Subject: Arkansas Nuclear One - Units 1 and 2
Docket Nos. 50-313 and 50-368
License Nos. DPR-51 and NPF-6
Additional Information Regarding Technical Specifications Change
Request to Delete Reactor Coolant Pump Flywheel Inspections

Response to Questions Related to "Relaxation of Reactor Coolant Pump Flywheel Inspection Requirements"

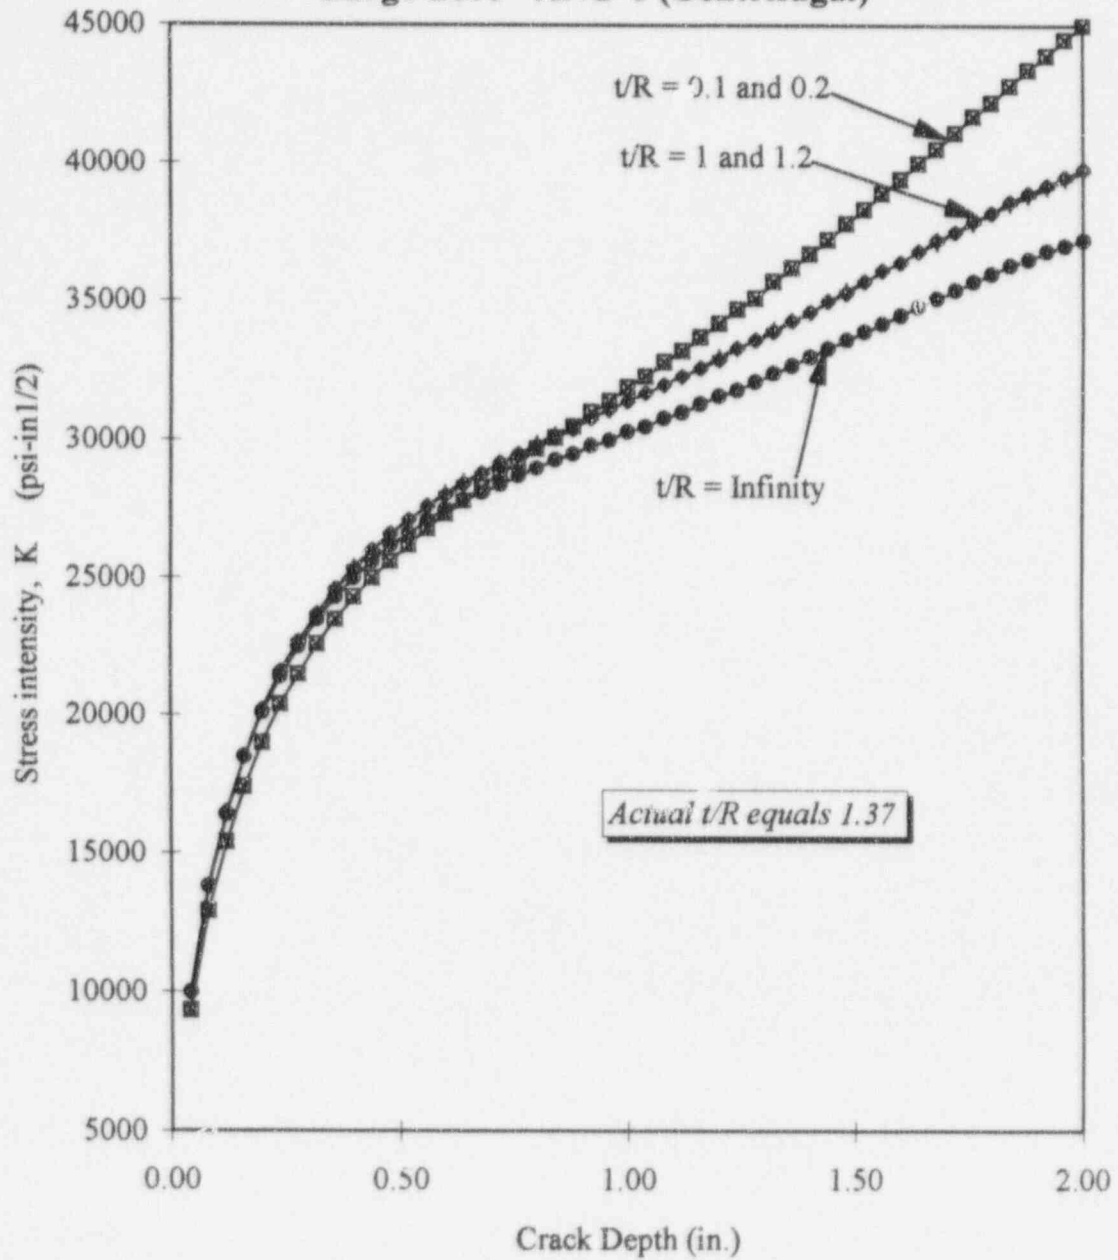
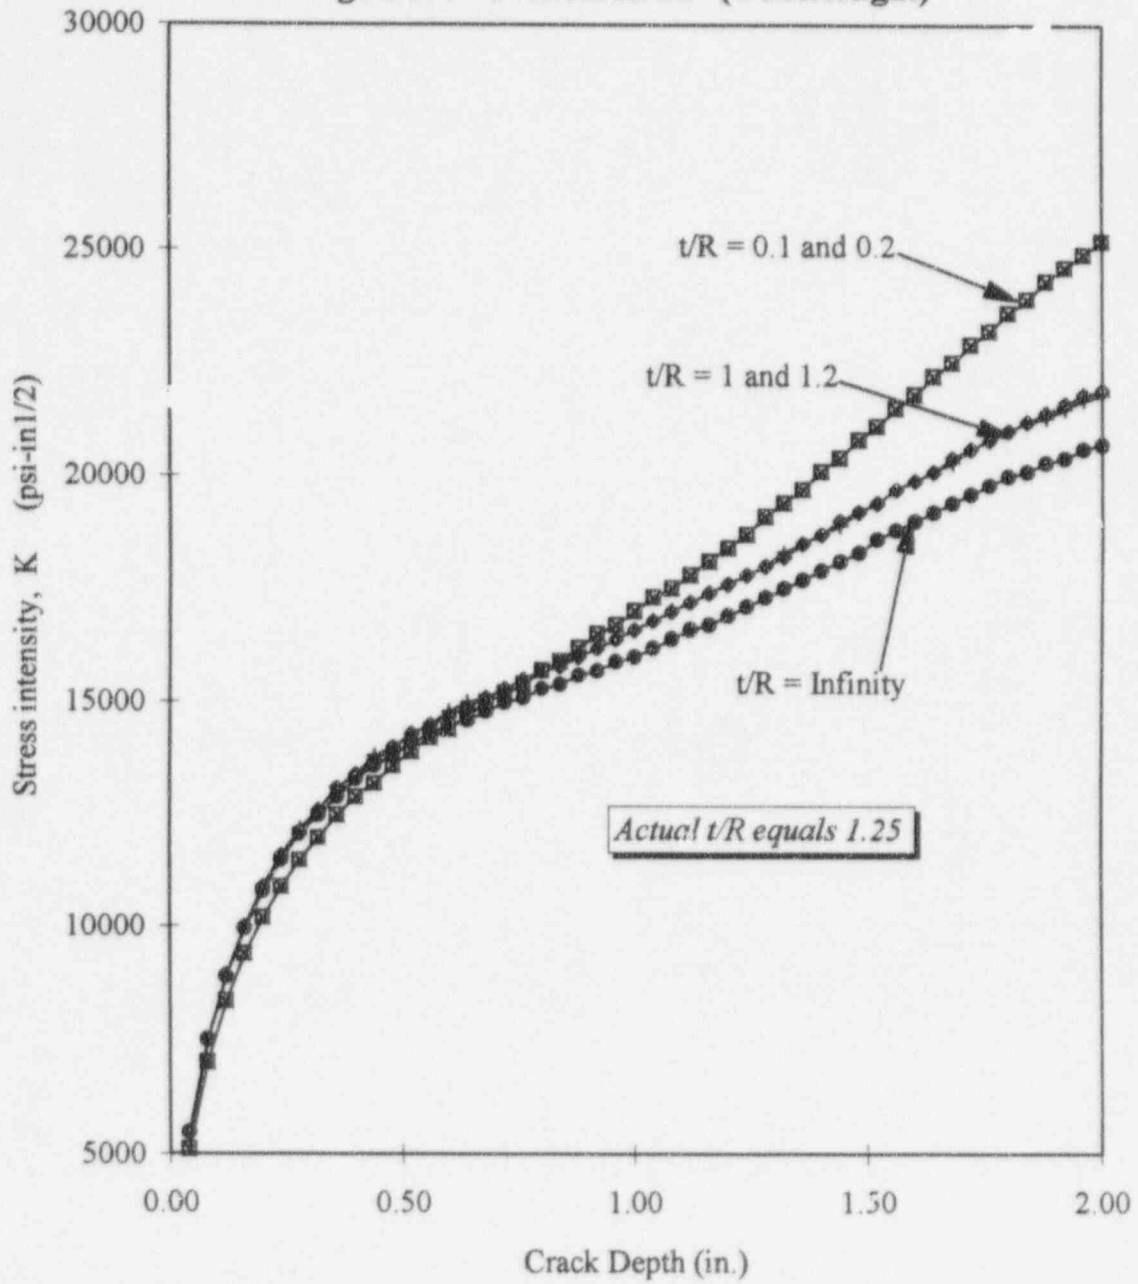
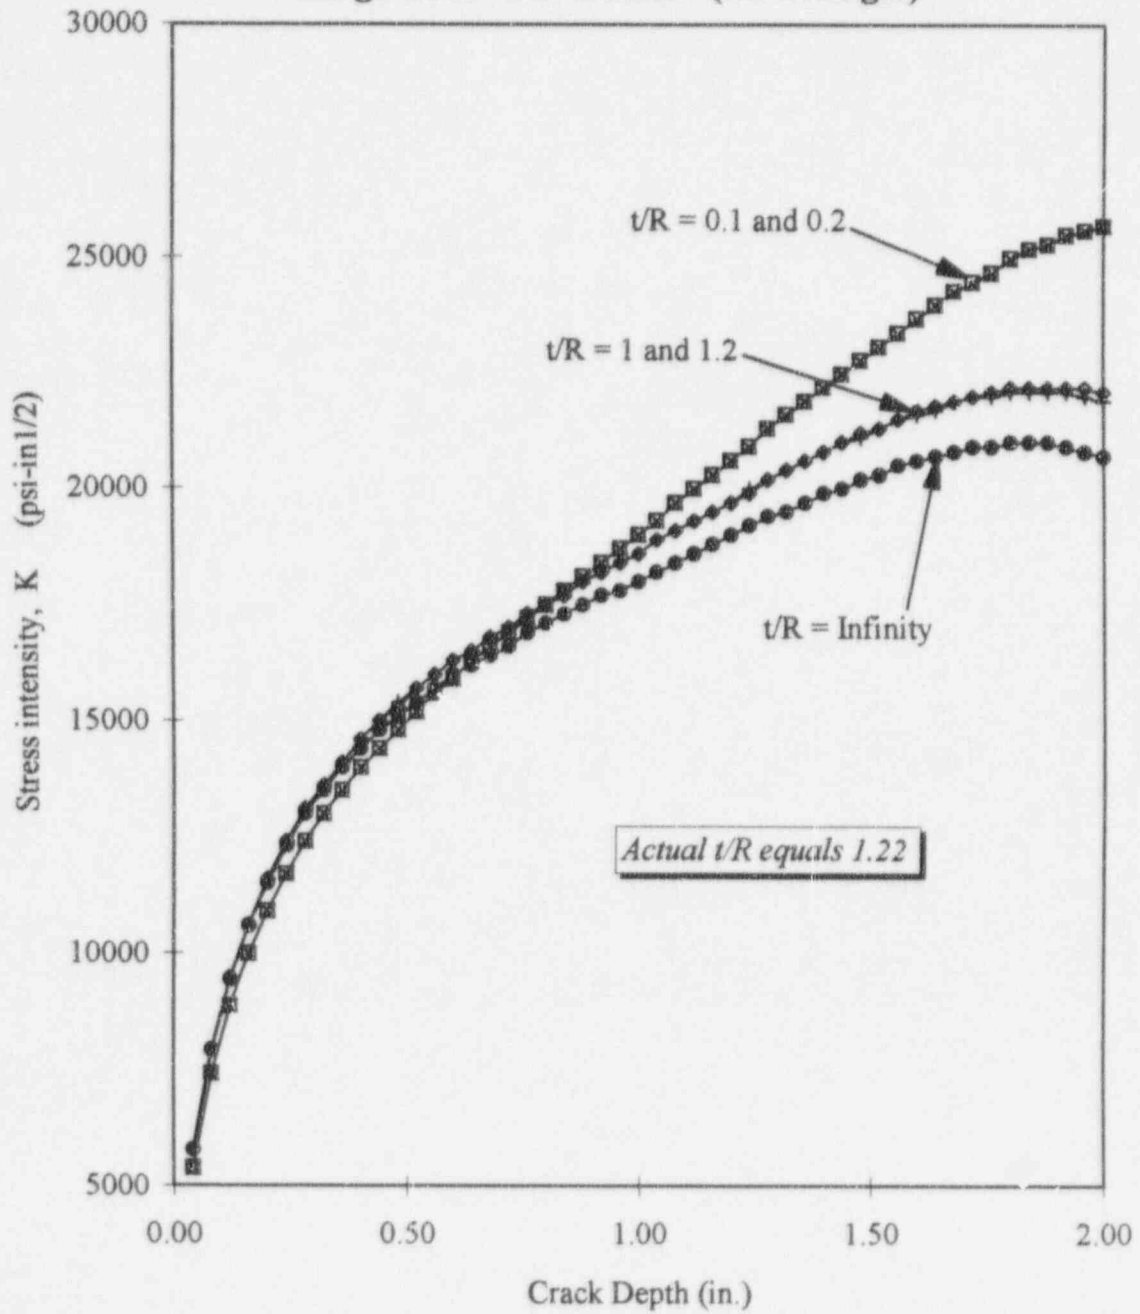
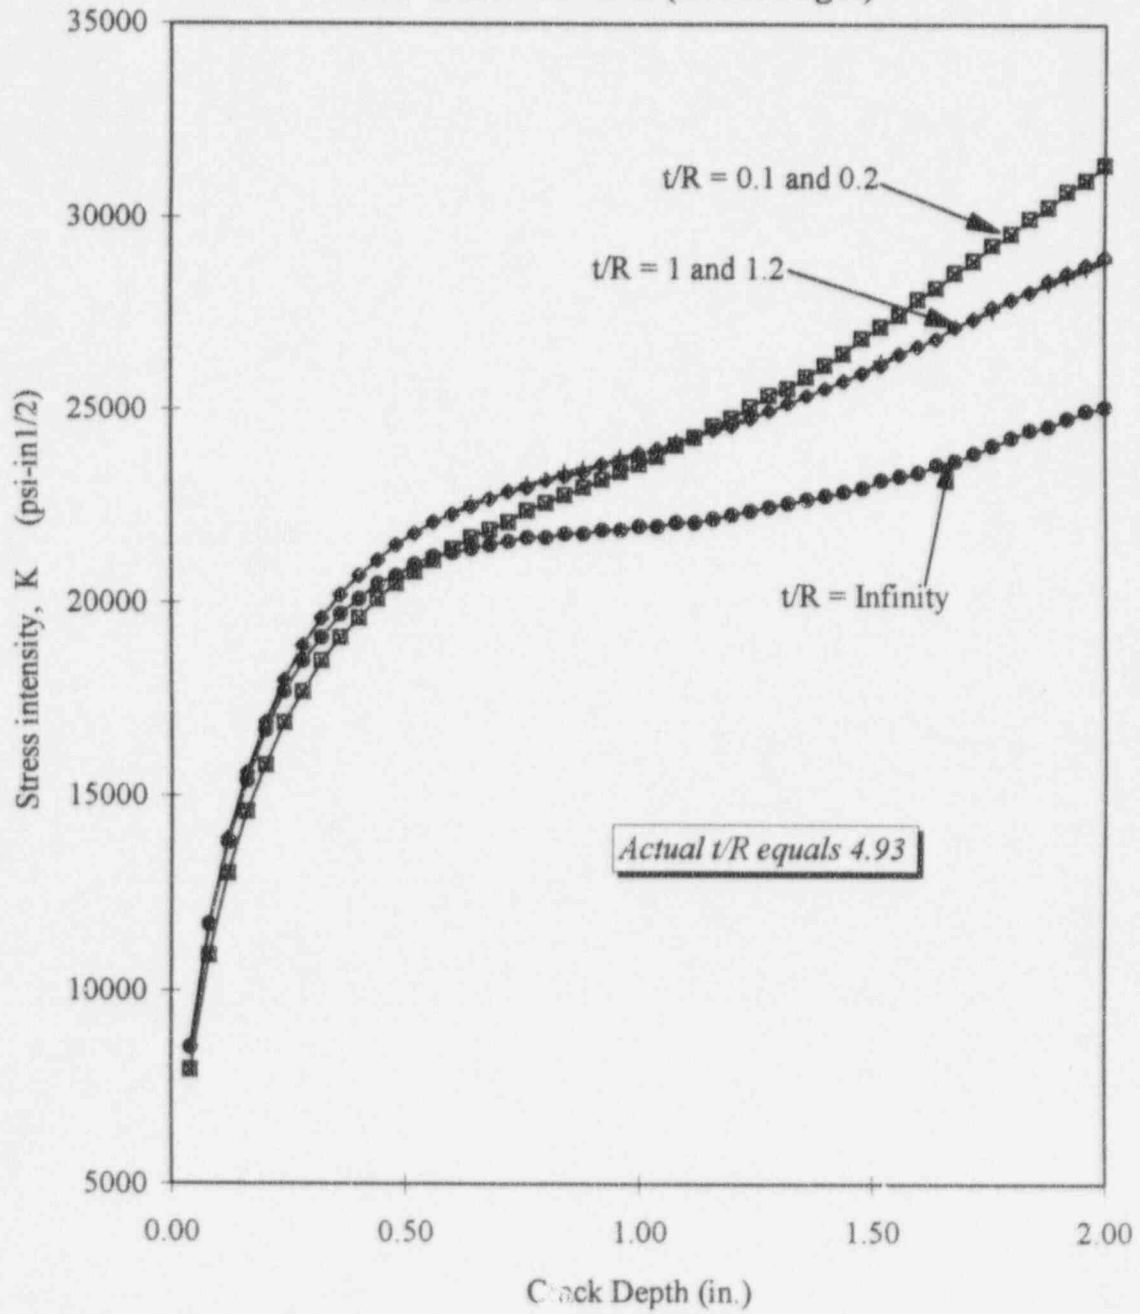
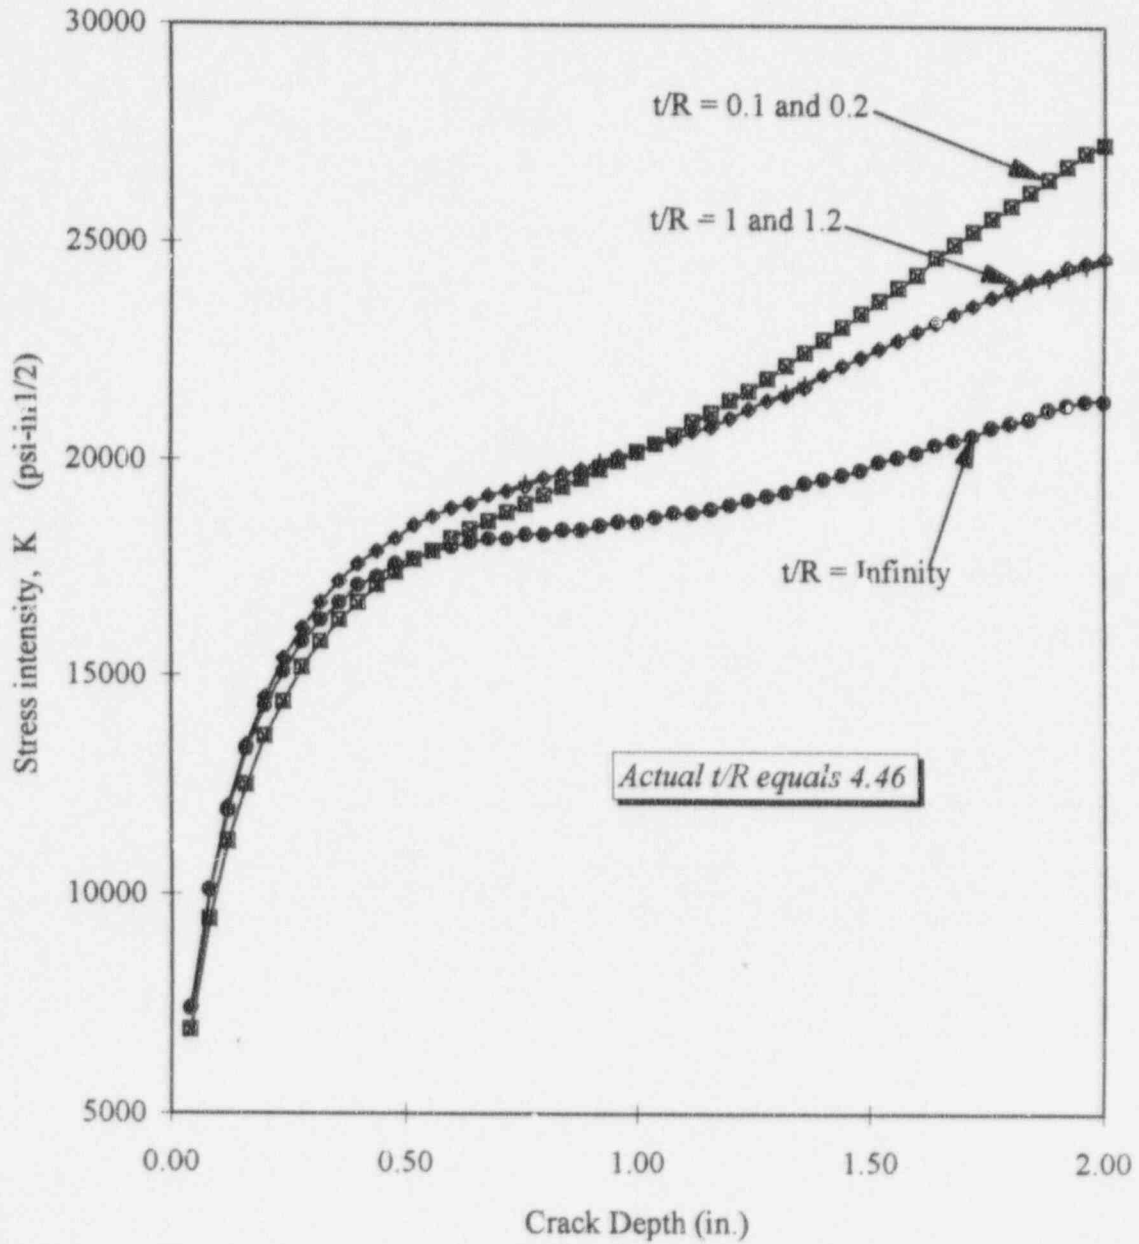
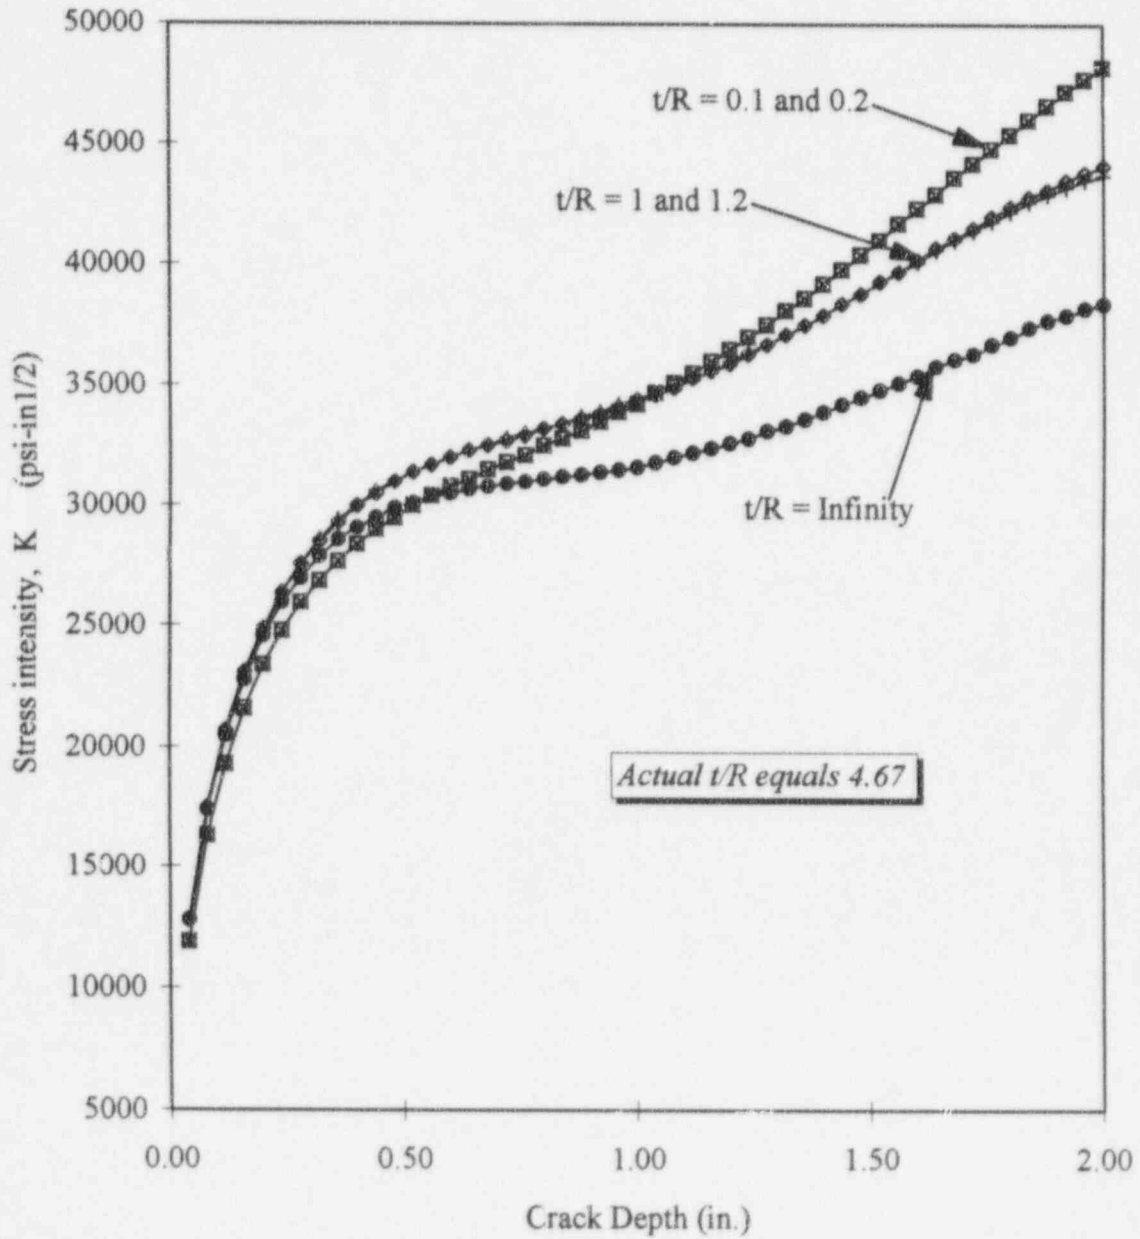
4. **Section 6.1.1, Centrifugal Stresses, Pg. 6-1: The finite element method (FEM) was employed in the stress analysis, but not in the fracture mechanics analyses. Support your fracture mechanics results by modifying the FEM model to include the postulated crack and then input the crack face pressure using the complete tangential stress distributions for the critical keyway regions in Figures 5-28 through 5-33 or demonstrate that the simplified models used are conservative.**

In the subject report, a model consisting of a longitudinal crack in the cylinder with $t/R = 1.2$ (t : thickness and R : inside radius) was chosen for the large-bore flywheels at ANO-1, Palisades, and St. Lucie Units 1 and 2. For the smaller bore flywheels at ANO-2, Millstone-2, and Waterford-3, a model consisting of a crack emanating from a hole in an infinite plate was chosen. To show the adequacy in the use of these models, sensitivity studies were performed to determine the effect of the geometric parameter, t/R , ranging from 0.1 to infinity. This was achieved by using various models from the *pc-CRACK* software library.

The analysis was performed for all the large-bore and small-bore flywheels for the plants considered in the subject report. The results of the evaluation in terms of stress intensity factor, K , versus crack length are presented in Figures 1 through 6.

For the large-bore flywheels of ANO-1, Palisades, and St. Lucie 1 and 2, the K variation with flaw length does not change significantly between the various t/R ratios for crack lengths up to about 1 inch as shown in Figures 1 through 3. The actual t/R ratios for these flywheels varies from 1.22 to 1.37, as shown in Table 2. In the subject report, a t/R ratio of 1.2 was used to perform the evaluation which, for analysis purposes, is slightly more conservative than the actual t/R values for these large-bore flywheels shown in Table 2. Hence, the results presented in the subject report are conservative.

The K versus flaw size distributions for the small-bore flywheels are shown in Figures 4 through 6 for ANO-2, Millstone-2, and Waterford-3. The actual t/R ratios for these flywheels vary from 4.46 to 4.93 as shown in Table 2. In the evaluation in the subject report, a crack emanating from a hole in an infinite plate with t/R of infinity was used. This model, although slightly less conservative than the actual t/R values for the flywheels for crack lengths greater than 0.75 inches, is acceptable considering the relatively large t/R ratios of these flywheels. To determine the sensitivity of the t/R ratio, the allowable flaw sizes were calculated using both models with t/R values of 1.2 and infinity, as explained in Item 5 below, even though it is believed that the t/R ratio of infinity more closely represents these small-bore flywheels. Both models yielded acceptable results.
